UNITED STATES
DEPARTMENT OF THE INTERIOR
BUREAU OF LAND MANAGEMENTFORM APPROVED
OMB NO. 1004-0137
Expires: January 31, 2018**SUNDRY NOTICES AND REPORTS ON WELLS**
*Do not use this form for proposals to drill or to re-enter an abandoned well. Use form 3160-3 (APD) for such proposals.*5. Lease Serial No.
NMNM121473

UH SO 10 P3 15#

30-015-43930

Chevron respectfully request the ability to change the BOPE rating for the selected wells mentioned at the header, from a 10M system to a 5M System. The maximum mud weight at 10500' for the pore pressure is a 13.0 ppg. The MASP under these assumptions will be 4788 psi. The attached documents below reflect a 5M system BOPE rating and test pressures.

20 X 13 3/8 X 9 5/8 X 5 1/2

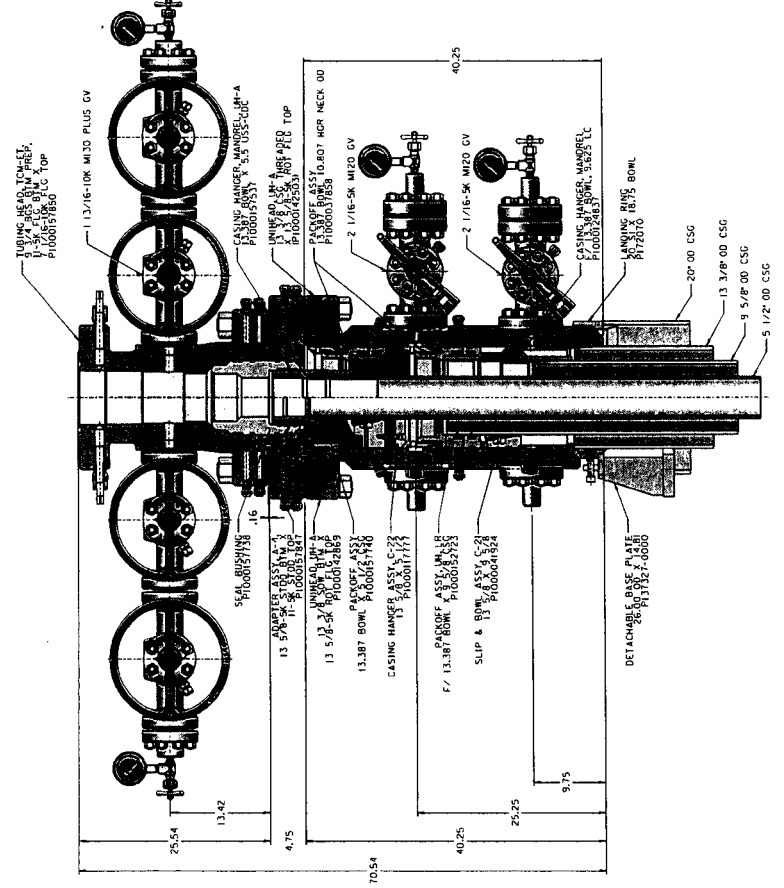
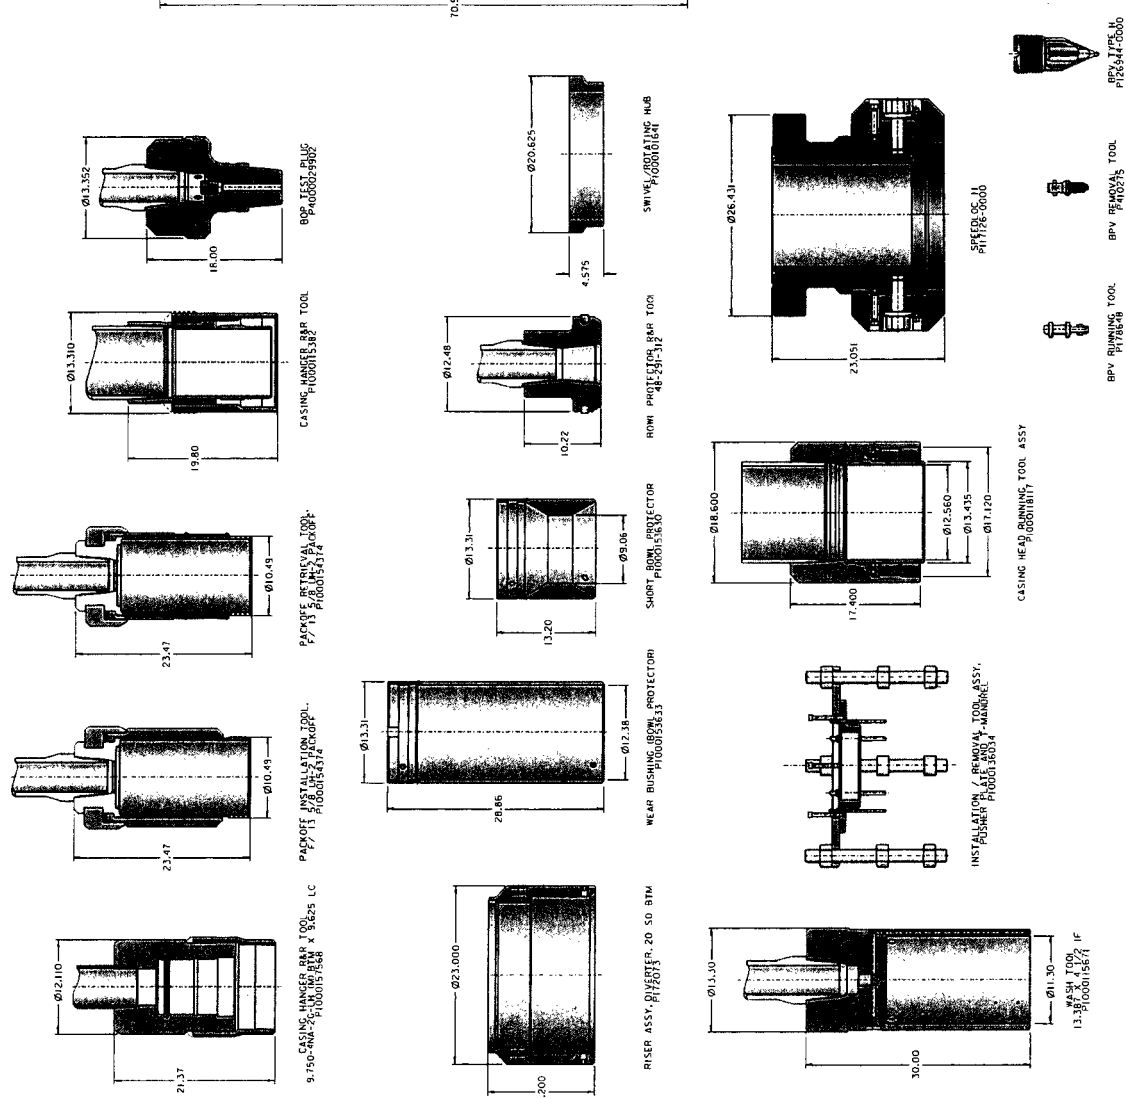
Chevron requests a variance to use a FMC Technologies UH-2 multibowl wellhead, which will be run through the rig floor on surface casing. BOPE will be nipples up and tested after cementing surface casing. Subsequent tests will be performed as needed, not to exceed 30 days. The field report from FMC Technologies and BOP test information will be provided in a subsequent report at the end of the

well. Please refer to the attached wellhead schematic.

Operator has proposed a multi-bowl wellhead assembly. This assembly will only be tested when installed on the surface casing. Minimum working pressure of the blowout preventer (BOP) and related equipment (BOPE) required for drilling below the surface casing shoe shall be 5000 (5M) psi.

- a. Wellhead shall be installed by manufacturer's representatives, submit documentation with subsequent sundry.
- b. If the welding is performed by a third party, the manufacturer's representative shall monitor the temperature to verify that it does not exceed the maximum temperature of the seal.
- c. Manufacturer representative shall install the test plug for the initial BOP test.
- d. Operator shall perform the intermediate casing integrity test to 70% of the casing burst. This will test the multi-bowl seals.
- e. If the cement does not circulate and one inch operations would have been possible with a standard wellhead, the well head shall be cut off, cementing operations performed and another wellhead installed.
